<b>Docket Number:</b>	20-SPPE-03
<b>Project Title:</b>	Gilroy Backup Generating Facility
<b>TN #:</b>	239193
<b>Document Title:</b>	GBGF Revised Project Description - Addition of BESS Facilities
<b>Description:</b>	N/A
<b>Filer:</b>	Scott Galati
<b>Organization:</b>	DayZenLLC
<b>Submitter Role:</b>	Applicant Representative
<b>Submission Date:</b>	8/5/2021 11:32:42 AM
<b>Docketed Date:</b>	8/5/2021

## **SECTION 3.0 PROJECT DESCRIPTION**

Figure 3.2-5 BESS Site Plan

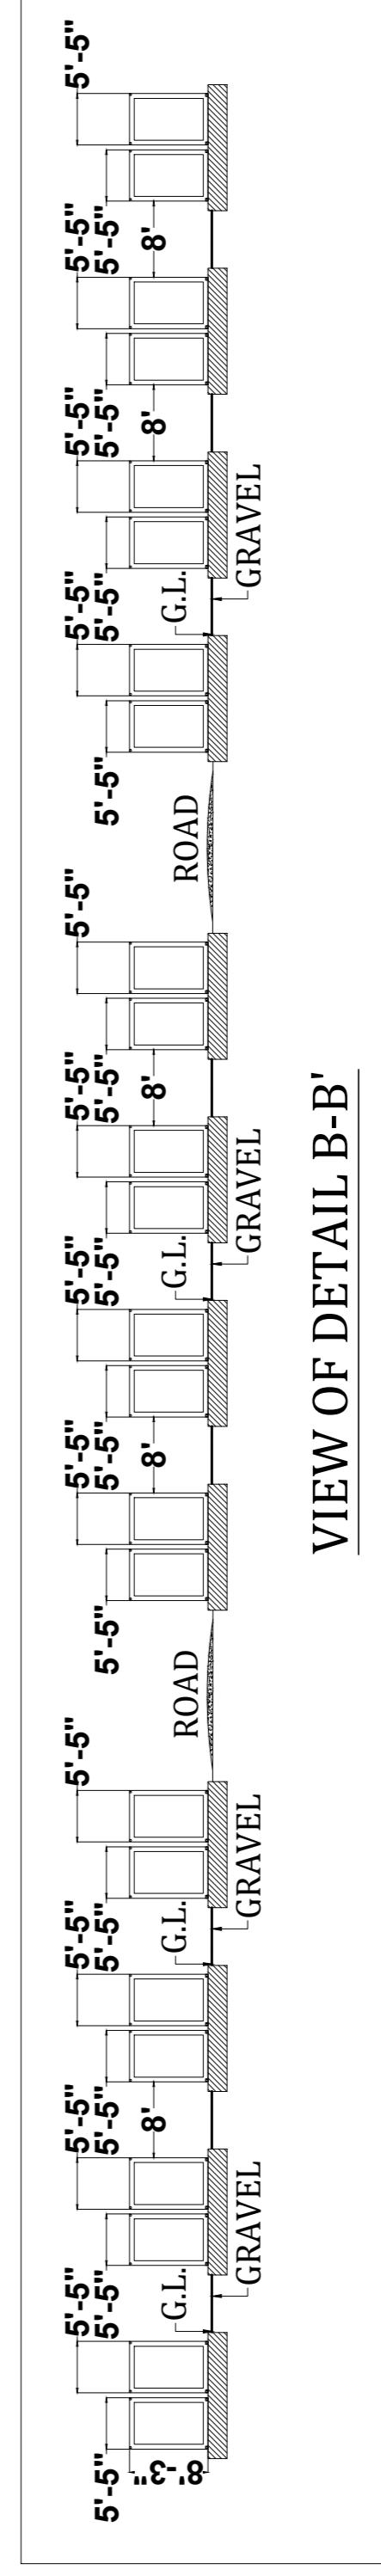
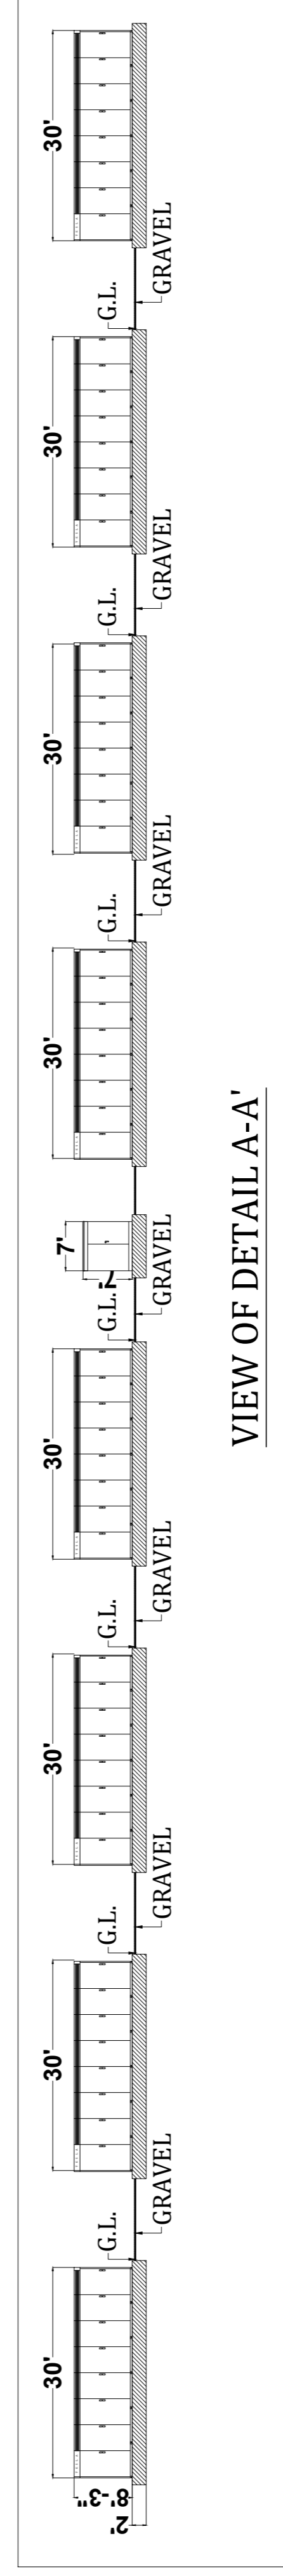
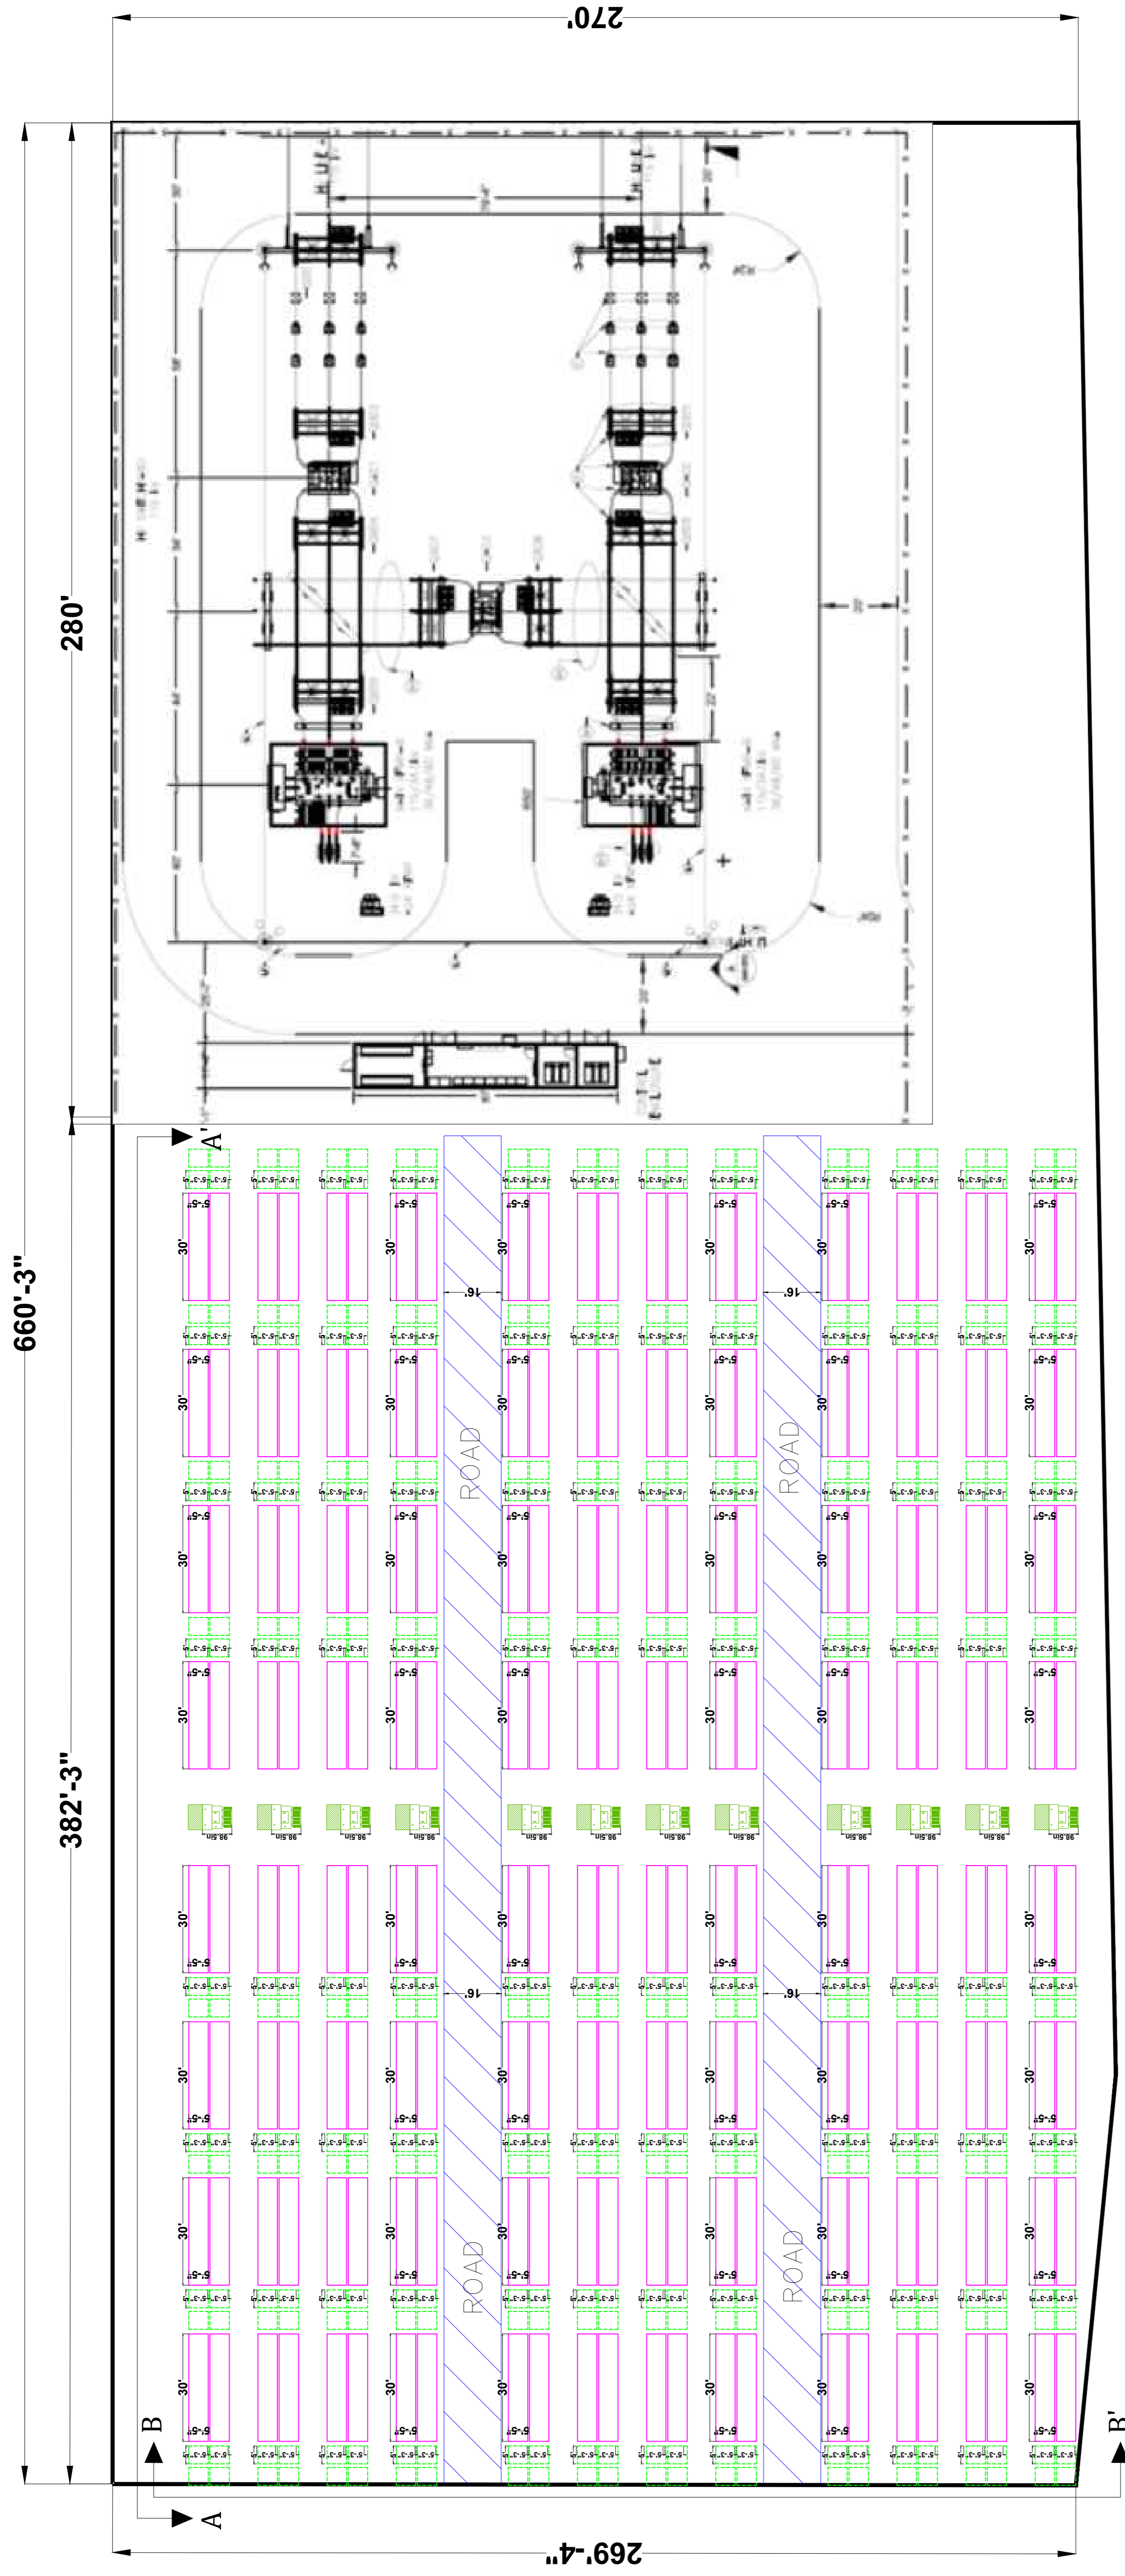
The BESS facilities have not yet undergone final design. ADS is considering constructing a BESS at two locations within the current site boundary; one within the eastern portion of the site and one within the area identified for the on-site substation. Both locations are shown on Figure 3.2-5-, Figure 3.2-6 includes a more detailed layout and elevation of the BESS facility to be located within the substation area. Figure 3.2-7 includes a single-line diagram of one of the BESS facilities.
